**ACCESSIBILITY CODE WORKGROUP
REPORT TO THE FLORIDA BUILDING COMMISSION**

DECEMBER 7, 2009—MEETING V

FLORIDA ACCESSIBILITY CODE WORKGROUP REPORT

INDEX TO ISSUES DISCUSSED AT DECEMBER MEETING

Figure 604.8.1.1 Size of Wheelchair Accessible Toilet Compartment

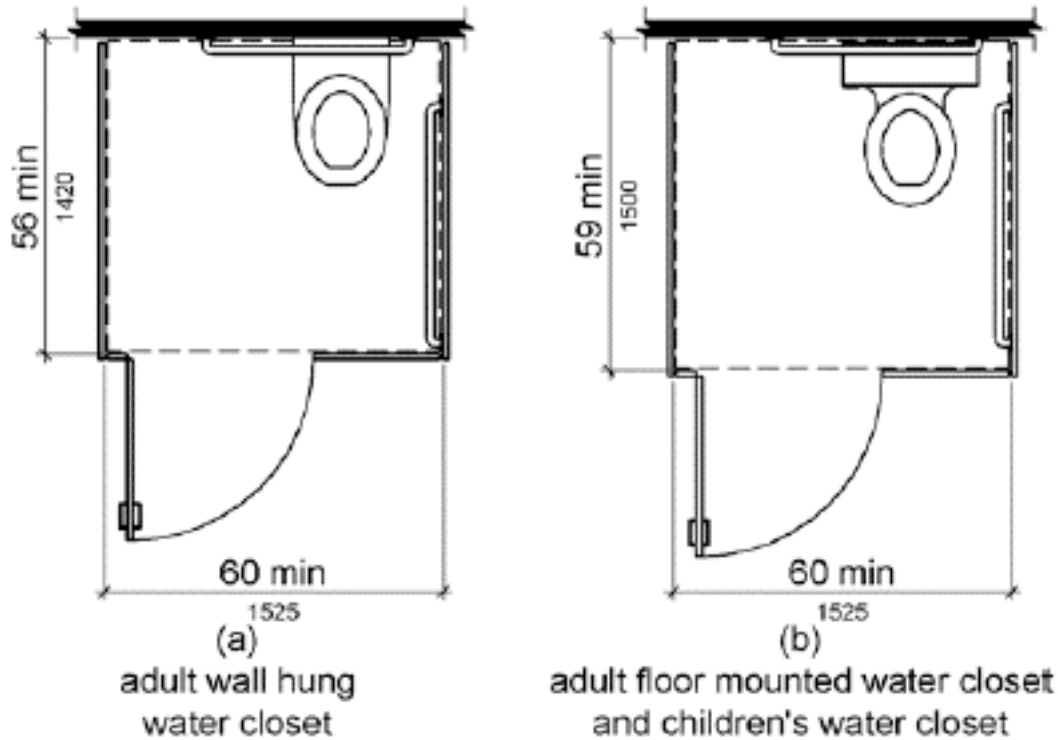
604.8.1.1 Page 118: Delete (a) and (b) references; replace with the following:
213.3.1 Page 34

Replace “s 4.17 Figure 30(a)” with “604.8.1.1 &
figure 604.8.1.1”

Add statement in scoping section 213.3.1 after “Where
provided, at least one toilet compartment must comply with
604.8.1”. Add note that references that FL’s requirement to
have an accessible lavatory in the accessible toilet
compartment does not apply to alterations per 604.8.1.1.1
note indicating “These forces do not apply...”

We use the organization recommendation provided above but quote the language from the law exactly,
without the emphasis you prefer. That will leave open to interpretation by declaratory statement what is
intended by “new construction”.
